**SUBJECT: Hawks Nest Hydroelectric Project (FERC No. 2512-069)
Glen Ferris Hydroelectric Project (FERC No. 14439-000)
Response to Comments Filed on the Updated Study Report**

**FIGURE 4-11
 NUMBER OF TIMES ACCIDENTALLY HITTING
 ROCKS/OBSTACLES WITHOUT STOPPING**

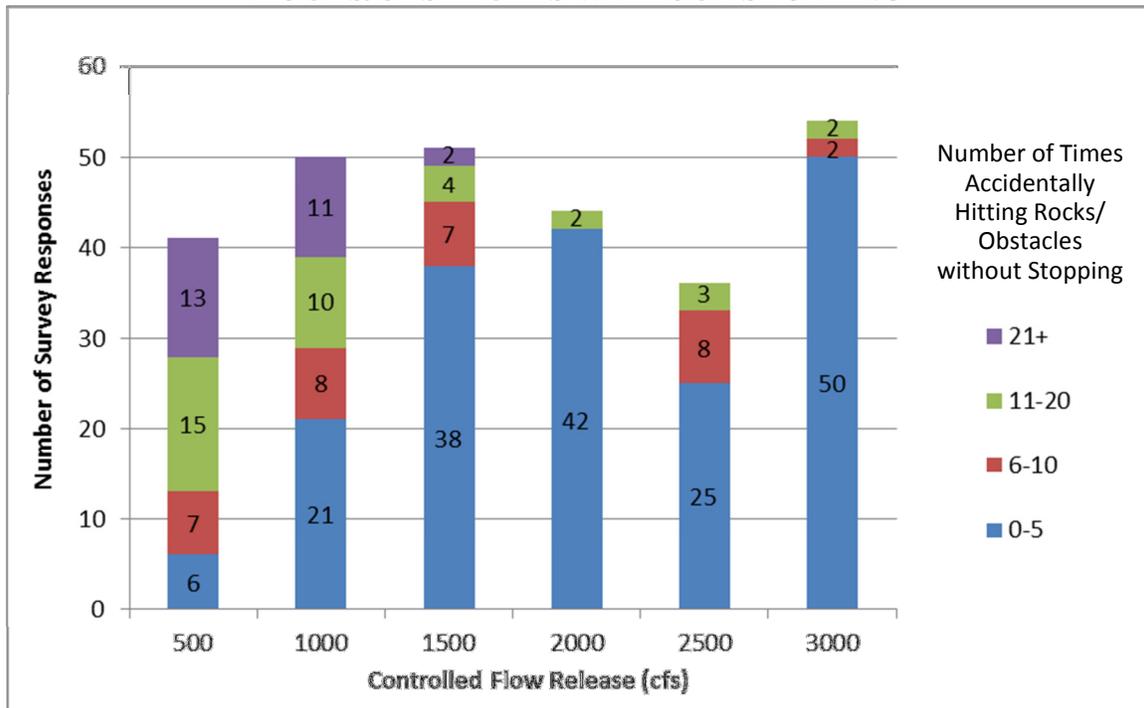
- 2. Figures 4-11 through 4-14 [of the Recreation Flow Assessment study report] should be presented as percentage of respondents rather than number of responses, similar to Figures 4-14 through 4-25. In their current state they fail to clearly convey the results.*

Hawks Nest Hydro's Response: Hawks Nest Hydro considers the study report to be complete (with the final version to be filed with the FLAs), in that it fulfills the study objectives and requirements of the RSP and SPD, and the Licensee does not propose further revision to the study report at this time. Therefore, Hawks Nest Hydro considers this comment and the comments below on the study report to be requests for additional information.

Hawks Nest Hydro does not propose to provide this additional requested information. The Recreation Flow Assessment study report provides significant detail and description of survey responses. Hawks Nest Hydro has taken great care to present information in an efficient and clear manner. Presenting these graphics in terms of number of participants is indeed clearer than a percentage basis in that it reflects actual participants' experience

and avoids any confusion or misinterpretation as “percent of the time.” For the above-referenced figures, a percentage is readily derived by dividing the number in any given bar segment by the sum of numbers in that bar. For example, in the graph below, 92.5% (50 divided by 54) of participants reported the number of times they accidentally hit rocks/obstacles without stopping to be in the 0-5 range at the 3,000 cfs controlled whitewater release.
